HILLS OF GOLD PRESERVATION INC 1800437

OBJECTION

PUBLIC SUBMISSION TO THE ENVIRONMENTAL
IMPACT STATEMENT FOR HILLS OF GOLD
WIND FARM PROPOSAL ID NO.SSD9679

Map presented to CCC on September 22, 2020

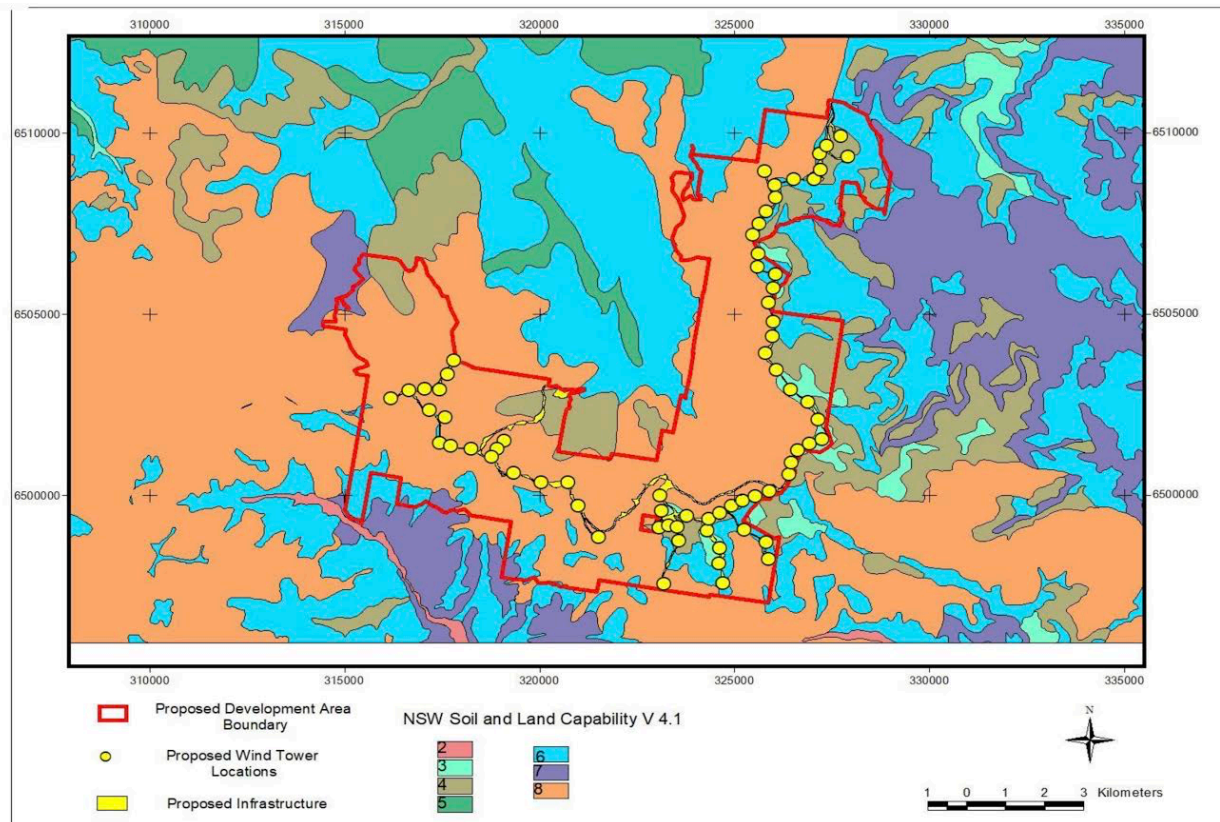
HOGPI members are concerned that when the Class 8 soil map was presented on screen at the Hills of Gold Wind Farm CCC on September 22nd, 2020 the legend was left off the map, and only a description of the Class 8 soil read out. A community member requested a map with a printed legend. It has since been added to the CCC minutes.

Dr Banks identified a significant error in Land Soil Capability coding, which has been corrected in the state database following necessary NSW Government protocols. It is expected to be updated online by the end of January. The LCS maps in the EIS and Appendix are incorrect. Revision of mapping gives more serious weight to erosion hazard within the project development, raising it from “low to moderate” to “high to extreme”. Around half of the proposed development and 33 wind turbines are on mass movement dominated land with very high erosion risk.

- redo Soil and Water Assessment based on correct Land and Soil Capability mapping, paying particular attention to Class 8 soil, high erosion and mass movement risk.

Figure 7 Location of Project in relation to Dam

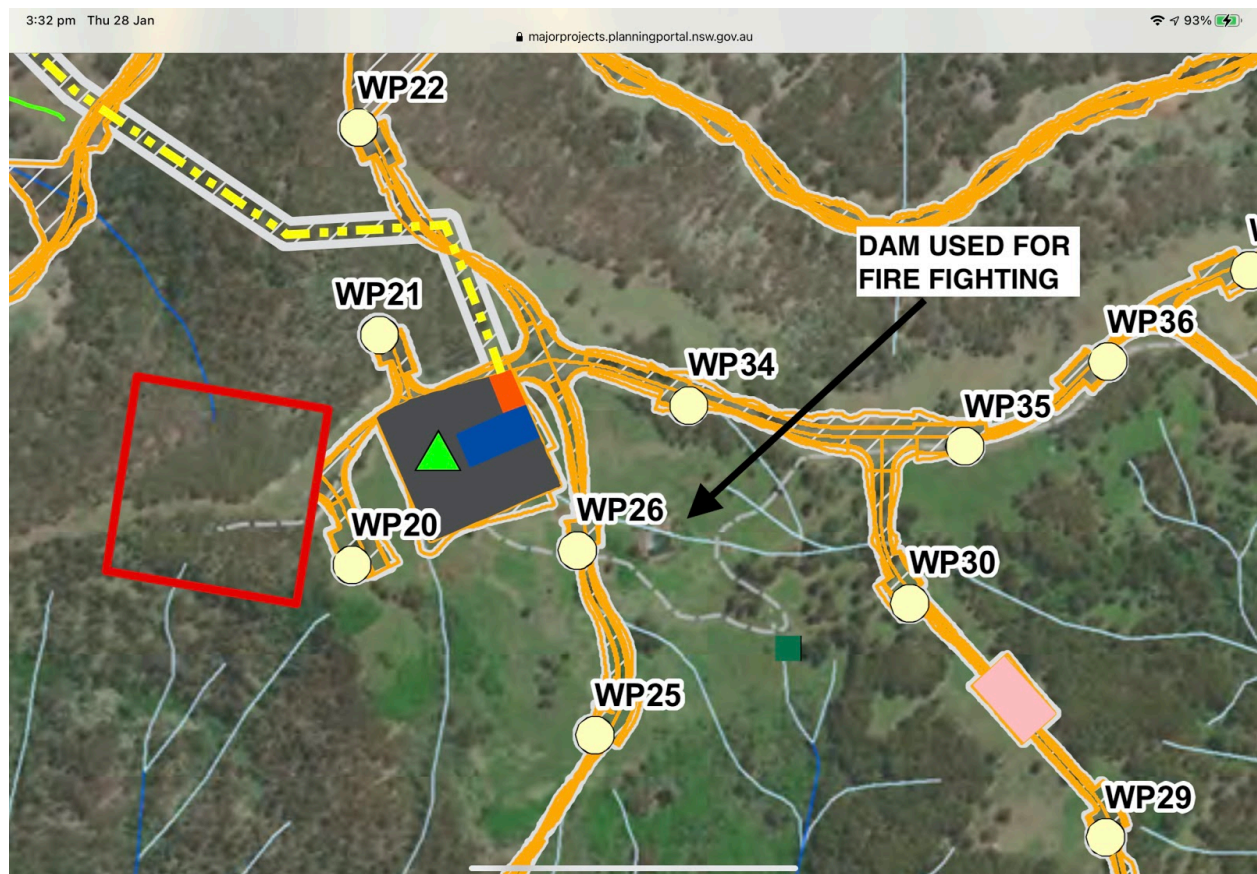
'Figure 7 Location of Project in relation to Dam' is incorrect. The arrow "Dam used in bushfires" is not positioned correctly. The actual dam used in bush fire aerial fighting is situated in an open paddock and will become not accessible should the BESS/O&M/substation complex be constructed. It will also be obstructed by turbine WP26.

- follow up CASA with request for review of assessment referred by Planning,
- follow up organisations that have not responded to correspondence.
